ADNOC GAS
LONG TERM - EXECUTE STAGE
PROJECT 5.0 (P5)
EPCm FOR HABSHAN DBN
COMPANY PROJECT No. 30201-50150-LT-HE
WORK ORDER NO. 3000076501

Comments Resolution Sheet (CRS) - EPCm

COMPANY Trans. No.:	ADNOCGP-WTRAN-024424	Received Date:	6-Feb-26
COMPANY Doc. No.:	30201_50150_LT_HE-H4-278-17-23-001	Revision:	B
Document Title:	UNIT 278 - HABSHAN 4FOUNDATION LAYOUT & DETAILS FOR IES-201FOUNDATION SECTION & RC DETAILS	Status Code:	Code 2
ADNOC PM:	Dr Azharuddin Mohammed	EPCm. CONTRACTOR PM:	Sriram PS
ADNOC Reviewer:	Mohamed Elsadani, Mr Kiranbhai Kuntmal, Mr Vinodhkumar Ranganathan	EPCm. CONTRACTOR Originator:	Surajit Das

DRAWING TITLE: UNIT 278 - HABSHAN 4 FOUNDATION LAYOUT & DETAILS FOR IES-201 BUILDING FOUNDATION LAYOUT

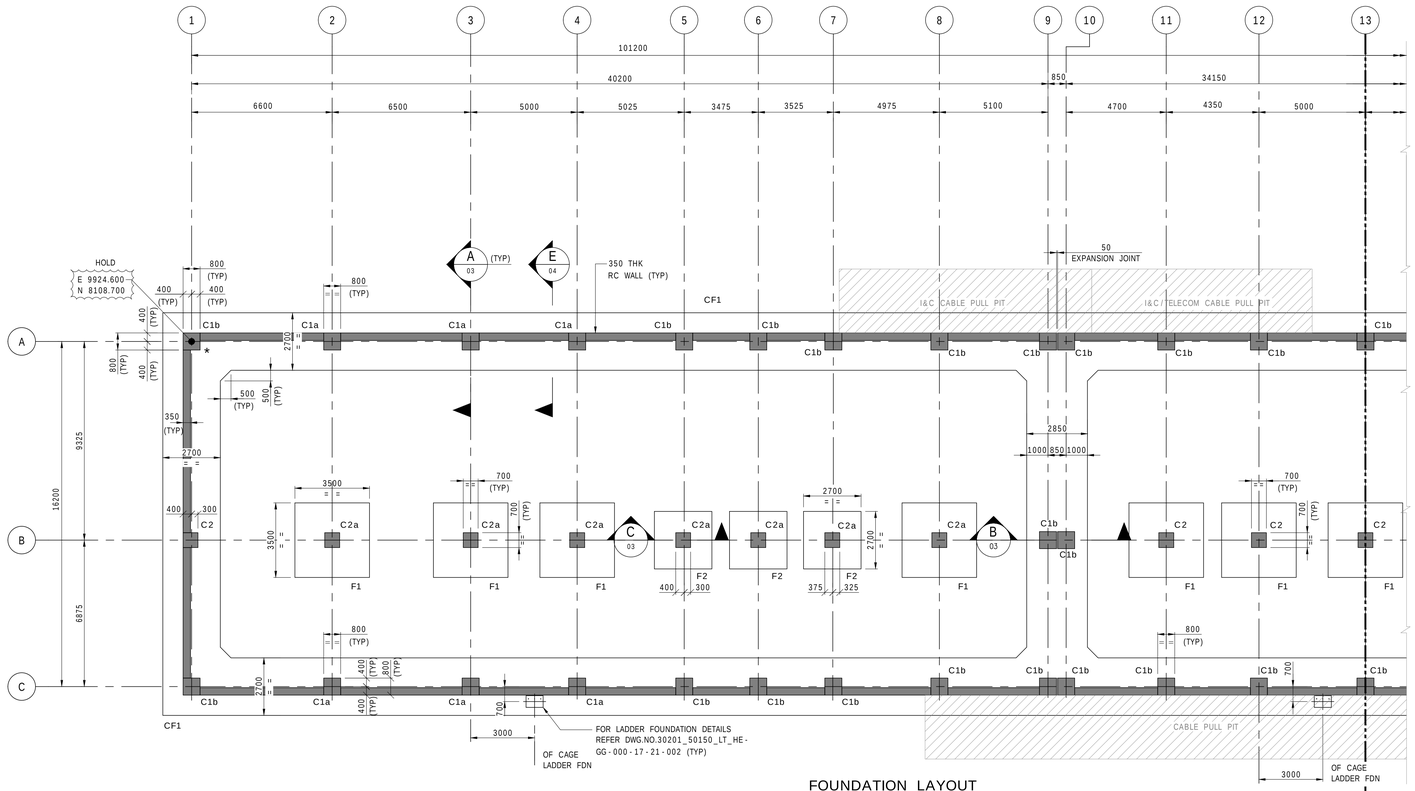
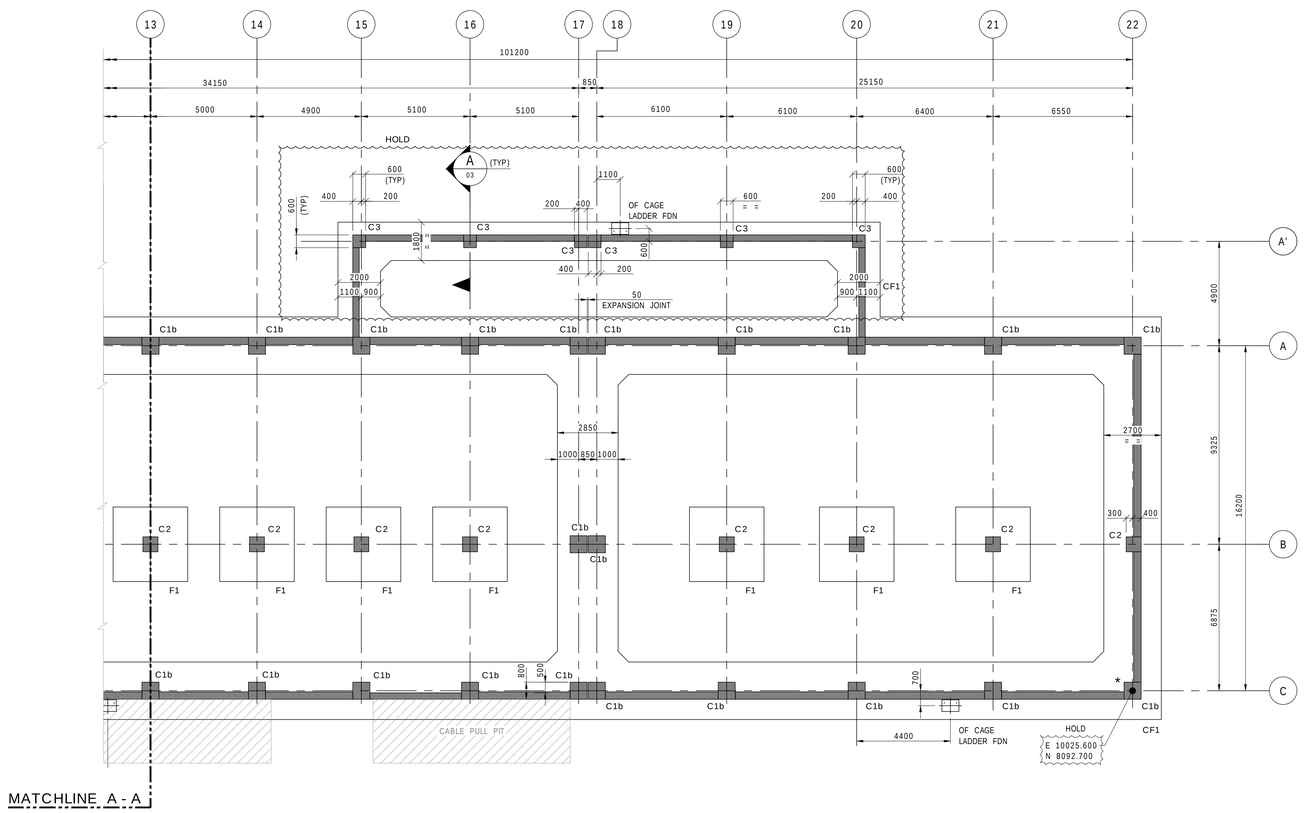
[1] 02	1. Update to mention Concrete grade, clear cover, rebar grade in a tabular format. 2. Update to include the MTO. 3. Update to mention the GWT in terms of levels. 4. Update to mention that : a) All concrete works shall be carried out as per addendum to AGES-SP-01-001. b) All earthworks shall be carried out as per AGES-SP-01-005 5. Earthworks shall also be based on the Geotech. recommendations. Ensure the same with Execute stage reports	Mr Vinodhkumar Ranganathan	1. Noted and updated. 2. Noted and updated. 3. Noted and updated. 4. Noted and updated. 5. Noted and updated.	Noted and closed				
	[1] 04	??	Mr Vinodhkumar Ranganathan	Noted and updated in Typical column RC details in Sheet 4.	Noted and closed				
	[1] 02	Align with CP vendor and update the notes suitably to GCC1	Mr Vinodhkumar Ranganathan	As CP vendor is not finalized . So it is kept under hold list.	Noted and updated	Not in the Hold list. Ensure to include in the Hold list	Noted and Updated.

[1] 02	Expedite to clear the wall for construction minimum upto the Grade level at the earliest with all the openings and cut out. Update to provide the reference drawings	Mr Vinodhkumar Ranganathan	Noted and updated and wall opening is kept under hold list.	Noted.	This is must requirement to finalize the dowel rebars from foundation. Expedite to resolve the Hold at the earliest.	Noted and will be updated after receipt of wall opening input.Now it is mentioned I the hold list.		
	[1] 02	For this also, strip footing required ?? check and update	Mr Vinodhkumar Ranganathan	Notedand updated and the width is optimesed from 2000 mm to 1800mm.	Noted.				
	[1] 03	For strip foundation, Rebar plan layout and sections are mandatory showing the curtailments, lapping distance, locations etc. The shown rebar detail is very conservative. Update to provide the rebar details only as required with the suitable contingencies. With Wall from Footing, shown rebar design and details seems to be not okay.	Mr Vinodhkumar Ranganathan	Noted and updated.	Noted and closed

TYPICAL REINFORCEMENT DETAILS FOR FOOTING TYPES CF1, F1, F2

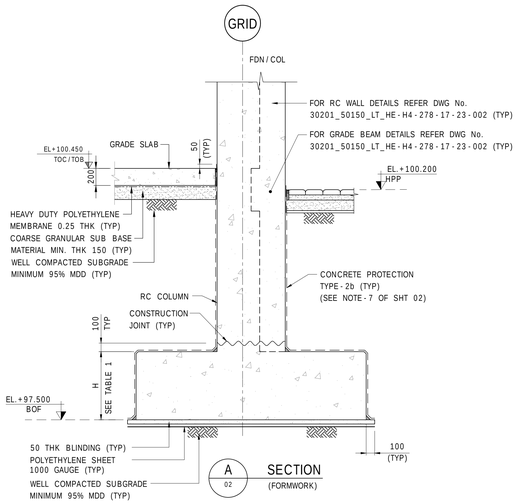
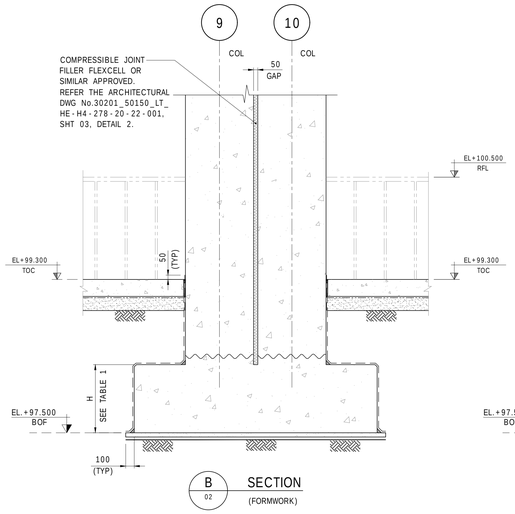
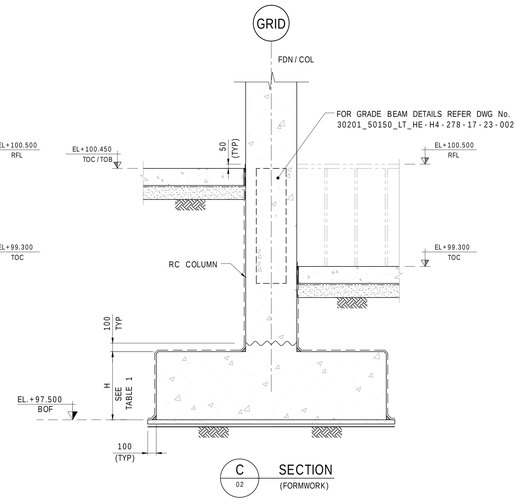
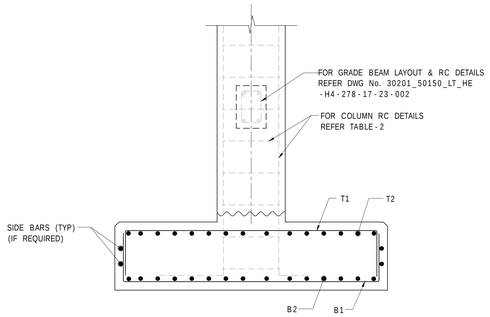
[1] 03	For Top rebar, provided seems to be very high. check and update	Mr Vinodhkumar Ranganathan	Noted and optimized.					
	[1] 04	Highly recommend to consider the spacing at 100mm within the footing	Mr Vinodhkumar Ranganathan	Noted and updated.					
	[1] 03	Identify in the Plan	Mr Vinodhkumar Ranganathan	Noted and updated.					
	[1] 04	Only 50% shall be lapped at one point and other 50% shall be staggered. Exact location of lapping and staggering shall be shown for GCC1 to execute. Recommend to show full detail to GCC1 instead of typical detail. Discuss with GCC1 and update as required.	Mr Vinodhkumar Ranganathan	Necessary note has been provided in the drawing.					
	[1] 04	optimize the grouping	Mr Vinodhkumar Ranganathan	Noted and updated.					
	[1] 03	Please refer the E08 type standard earthing installation from drawing 30201_50150_LT_HE-GG-000-16-21-001 for REINFORCEMENT CONCRETE STRUCTURE	Mr Kiranbhai Kuntmal	Noted and updated.

PLAN FOOTING FOR - CF1
(SCALE 1:100) (REINFORCEMENT)

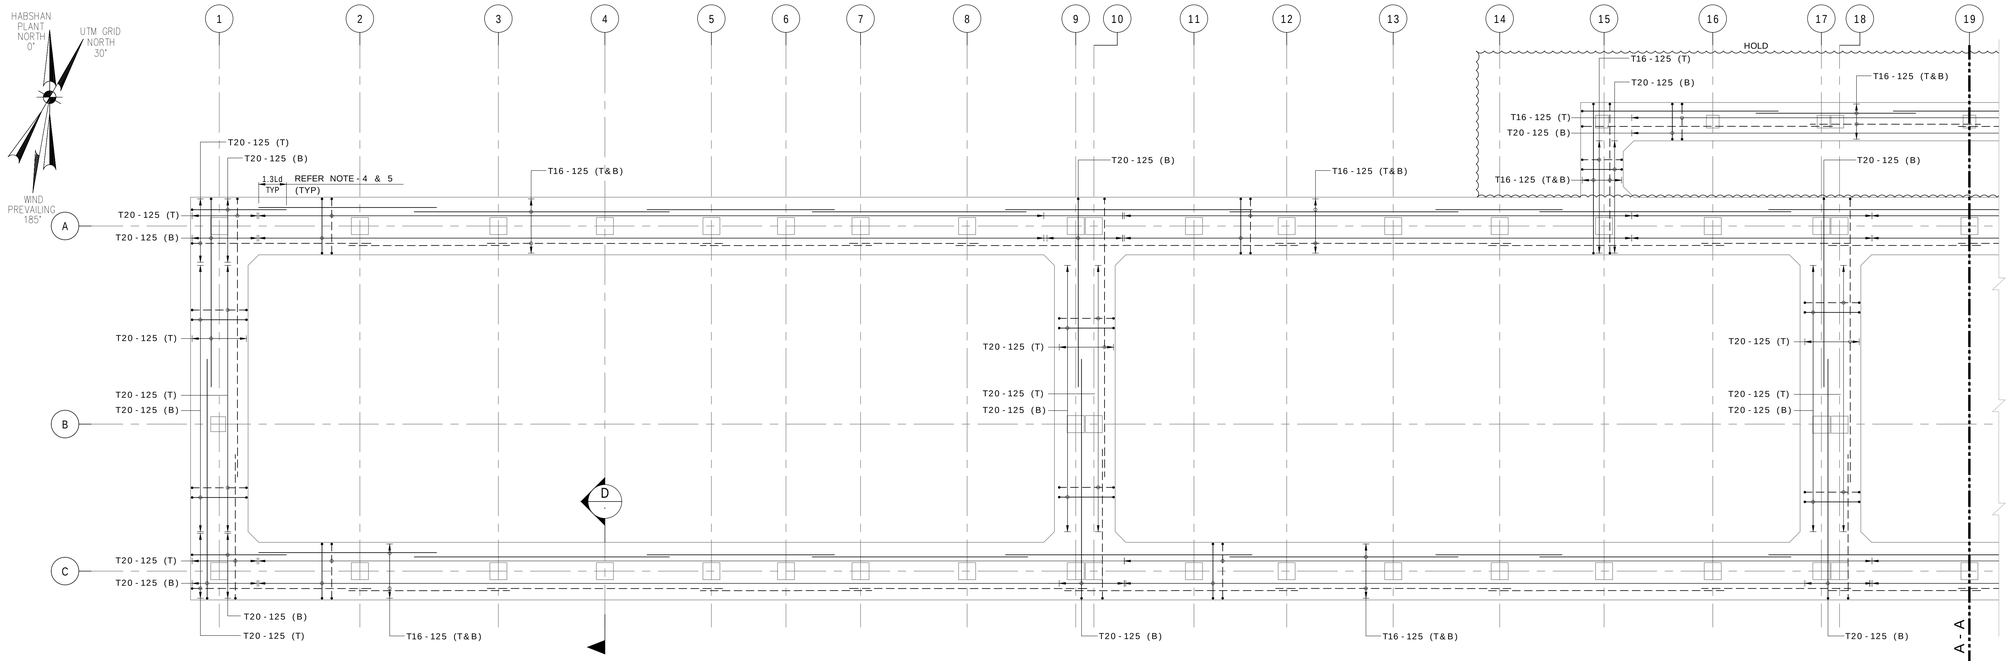
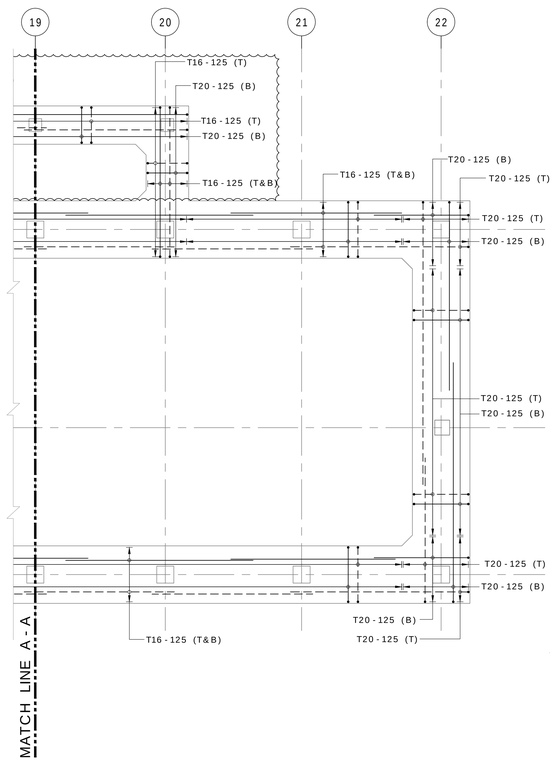
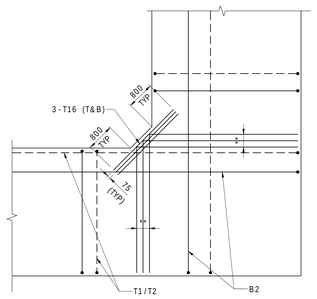
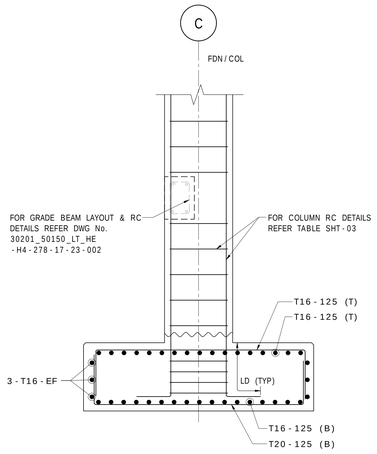
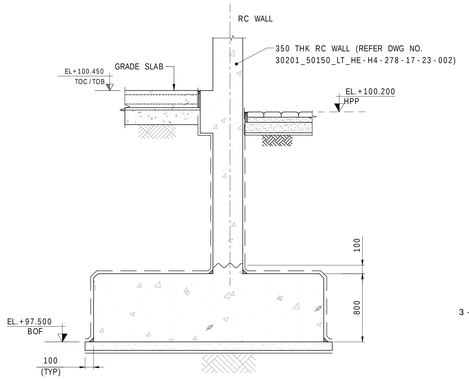
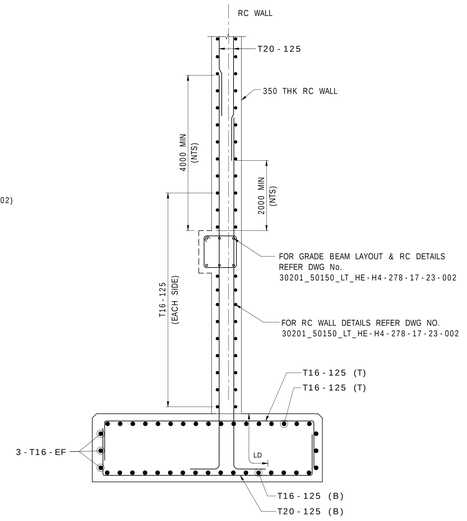
[1] 02	Ensure that the sealant is sufficient to accommodate the relative movement between the segments. Attach the check in the CRS and later include in the design report.	Mr Vinodhkumar Ranganathan	Max relative displacement is coming 8 mm which is less than 0.35X 50=17.5 mm .					
	[1] 03	Include the detail number and sheet number	Mr Vinodhkumar Ranganathan	Noted and updated.					
	[1] 03	T12	Mr Vinodhkumar Ranganathan	Noted and updated.					
	[1] 03	External wall is concrete. update	Mr Vinodhkumar Ranganathan	Noted and updated.					
	[1] 03	T10 @ 100C/C	Mr Vinodhkumar Ranganathan	Noted and updated.					
	[1] 03	Maintain clear cover	Mr Vinodhkumar Ranganathan	Noted and updated.					
	[1] 03	Splicing locations shall be shown in Engineering drawings to GCC1. Update	Mr Vinodhkumar Ranganathan	Noted and updated.					
	[1] 04	T16	Mr Vinodhkumar Ranganathan	Noted and updated as 20 dia bar at bottom.

[1] 04	Shown is not correct. may be scaling issue. check and update	Mr Vinodhkumar Ranganathan	Noted and updated.					
	[1] 04	Horizontal rebars shall be in the external	Mr Vinodhkumar Ranganathan	Noted and updated.					
	[1] 04	Blast wall design for IES-201 to be concluded before the IFC of this drawing. Discuss in advance to avoid delay and reworks.	Mr Vinodhkumar Ranganathan	noted and updated as 350 mm thik wall.					
	[1] 04	Ensure bottom rebar splicing is always at centre. Typical comment	Mr Vinodhkumar Ranganathan	Noted and updated.					
	[1] 04	T16 ? Check the correctness and update as required	Mr Vinodhkumar Ranganathan	Noted and updated as 20 dia bar at bottom.					
48	[1] 04	T20? For combined Top long rebar generally higher. check and update	Mr Vinodhkumar Ranganathan	Noted and updated as 20 dia bar at bottom.
